Data Request #	Section/ Page	Section	Topic	Information Request	Applicant Response
Veg-4	Part 4.8; Attachment L	Vegetation	Revegetation	Provide information clarifying how revegetation will lead to restoration. Within the WDFW Wind Power Guidelines, temporary impacts to habitats are those that are restored following construction. Within the definition “the goal of restoration of temporary impacts should be to restore habitats to a condition at least as good as its pre-project condition”.	The Vegetation and Weed Management Plan (to be provided in September 2023) will outline the native seed mixes that will be used during revegetation efforts in both grassland and shrubsteppe communities. Attempts to minimize temporary disturbance will be made, particularly temporary disturbance to shrubsteppe communities, which take longer to reestablish during revegetation. Revegetation of grasslands will be completed by the end of the growing season that follows the completion of construction. This will allow for reseeding during post-construction and ample time for the site to receive adequate rainfall, which is a limiting factor for revegetation in Eastern Washington. Shrubsteppe communities will

Figure 3 Prime Farmland

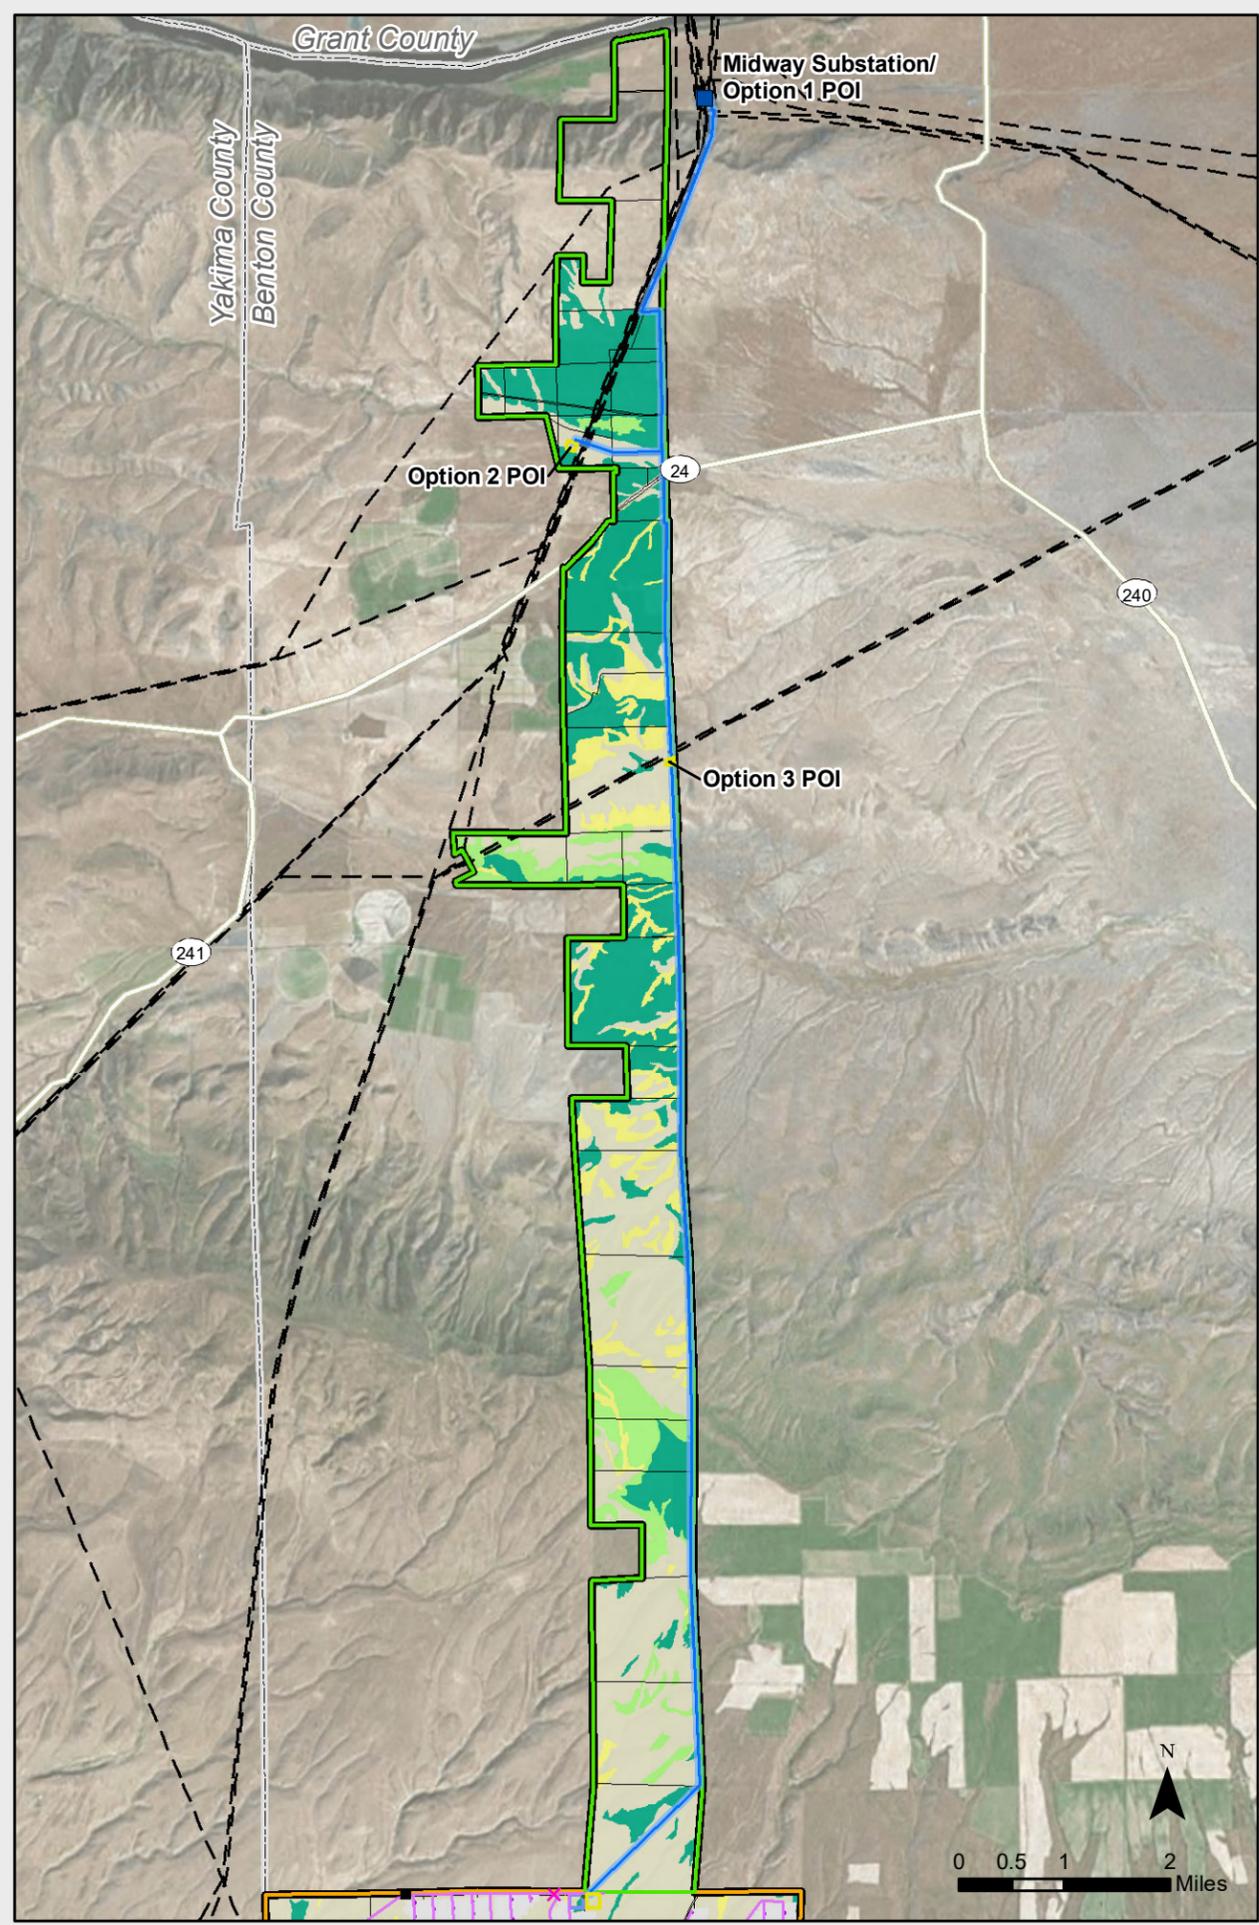
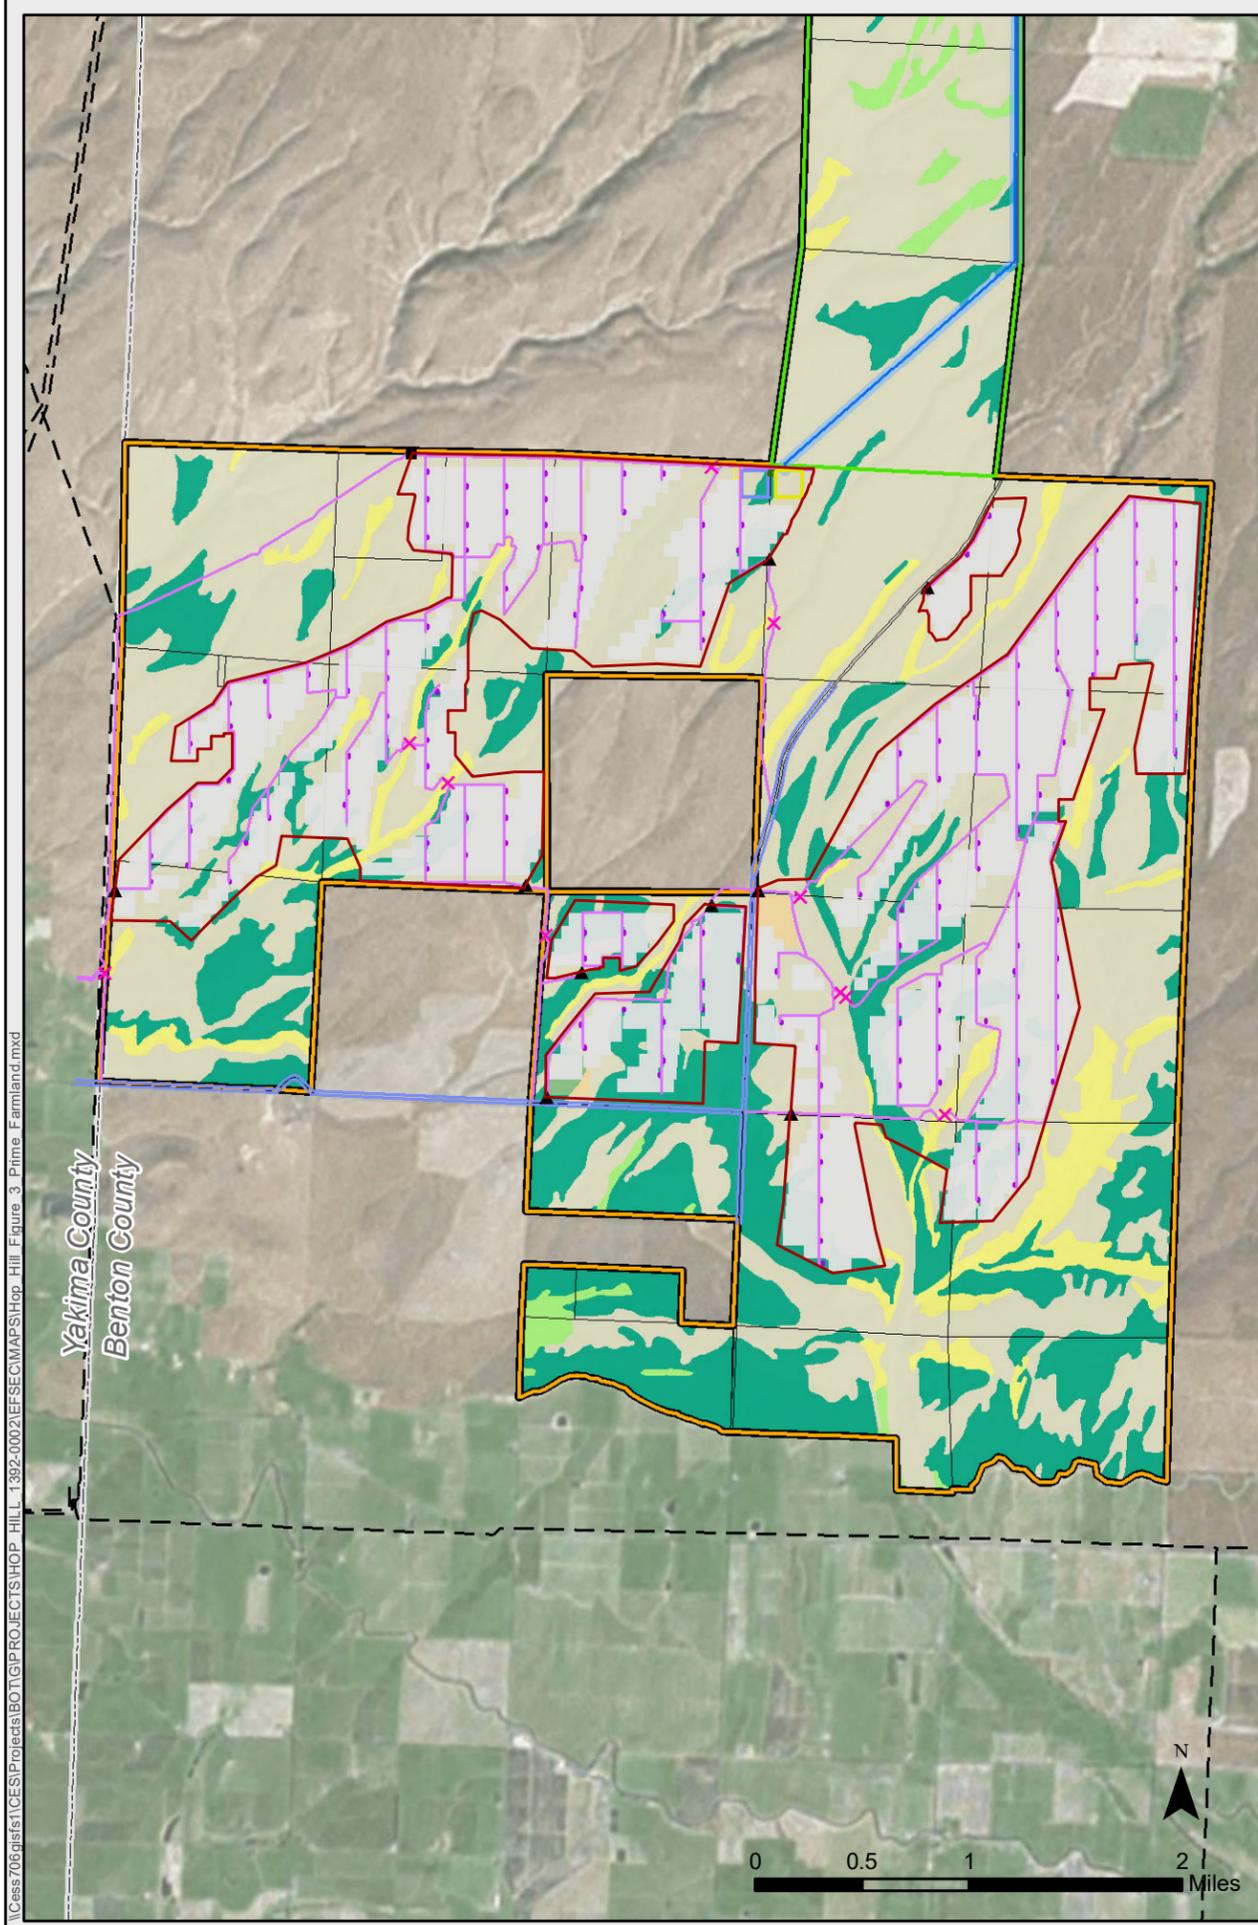
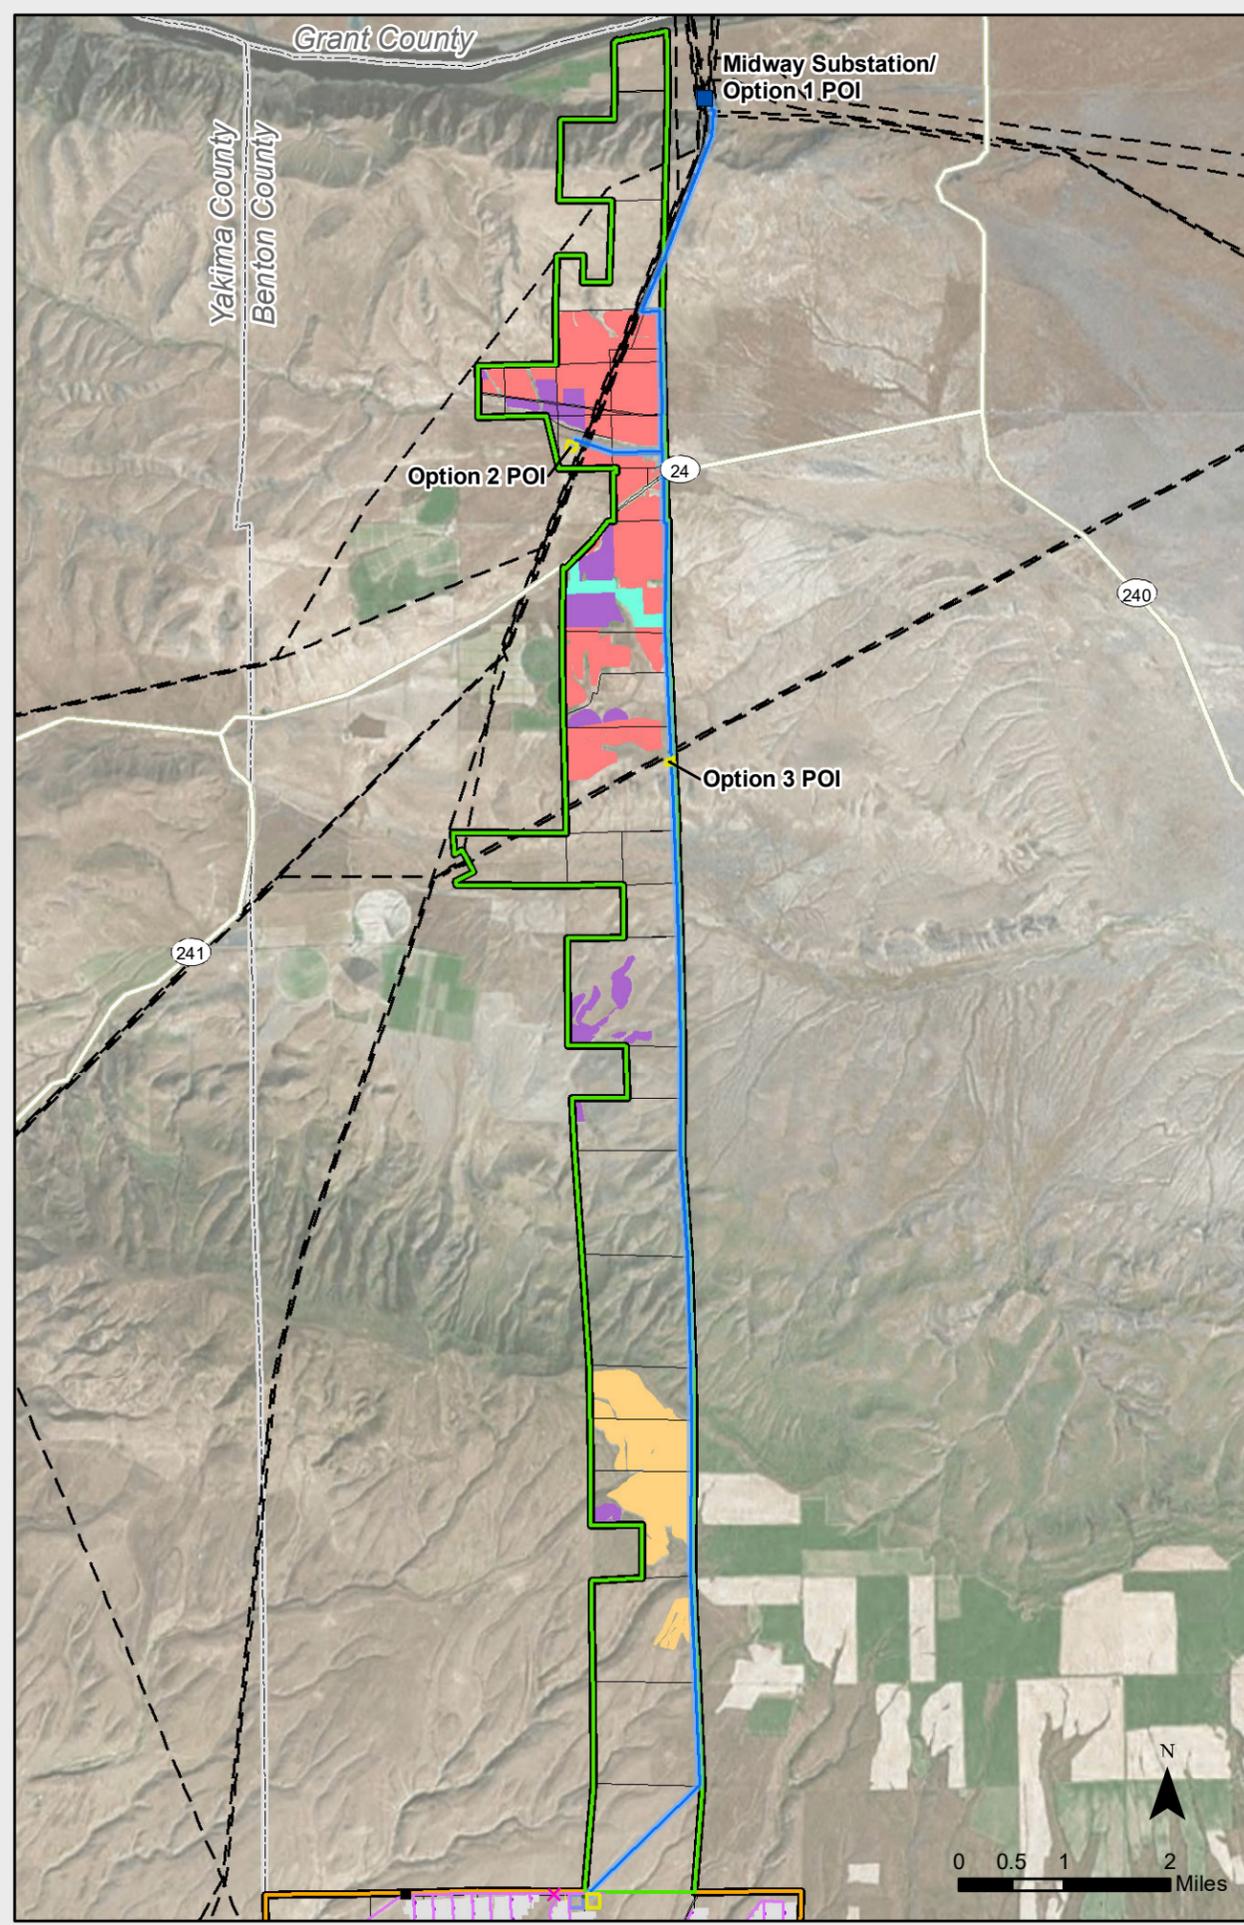
Land Use-24	Attachment D	Land Use, Natural Resource Lands & Shoreline Compatibility	Solar panels and other project components within the Siting Area	Provide a new figure, presenting Figure 3 in Attachment D of the ASC with an overlay of solar panels and other project components within the Siting Area for better presentation of prime farmlands that will be permanently disturbed.	Figure 3 to Attachment D of the ASC is revised and attached to include the preliminary site plan as updated and provided to EFSEC on April 26, 2023. See Attachment Land Use-24 .
